Our Ref: 3081/MK/TB/PW/180713

Re: Ravensworth East Resource Recovery Project – Proposed Amendment to Overburden Emplacement Area for DA 52-03-99 Mod 5

Figure 1.1 – RERR Revised Conceptual Mine Plan (Year 4)

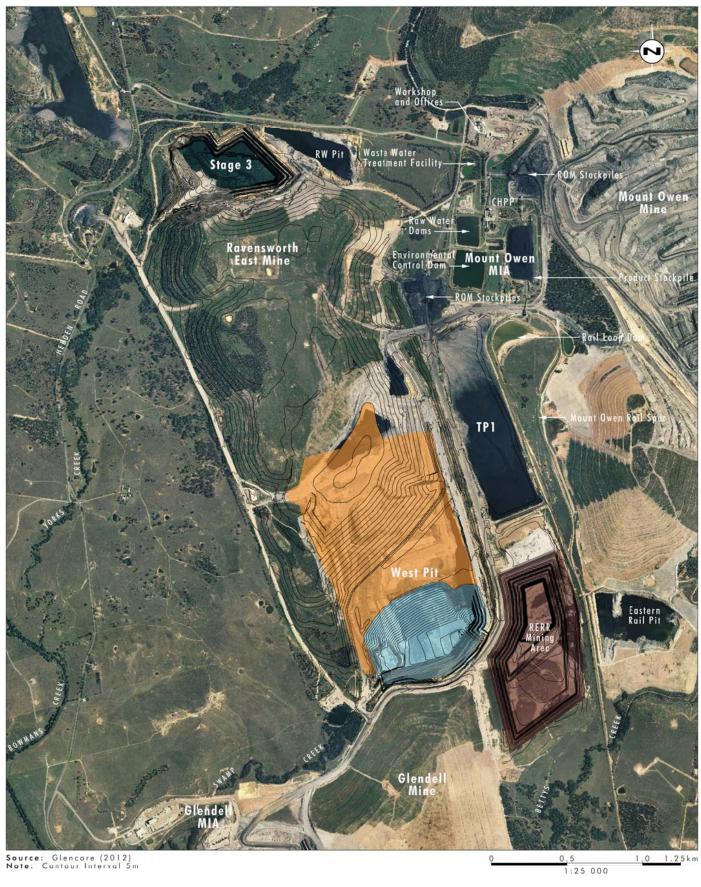
- Revisions to the conceptual mine plans for years four and five (see attached Figures 1.1 and 1.2) to include the co-disposal of coarse reject and overburden within the West Pit and the RERR mining area as mining progresses. This co-disposal will reduce the size of the RERR void at the end of mining operations within the Ravensworth East Mine and will confine overburden emplacement to the southern end of the West Pit Overburden Emplacement Area.

- Emplacement of overburden within the West Pit Overburden Emplacement area to a
 maximum height of RL 170 metres (previously proposed to RL 180 metres, currently
 approved to RL 160 metres). The additional 10 metres in height above that currently
 approved will allow a more natural landform to be achieved.

- The original conceptual mine plans required the disturbance of approximately 54.2 hectares of mine rehabilitation within the West Pit Overburden Emplacement Area, comprising of immature rehabilitation forest complex and rehabilitation grassland complex. The revisions to the conceptual mine plans (years four and five) negates the requirement to disturb approximately 41.6 hectares of rehabilitated grassland and forest complex from what was originally proposed.
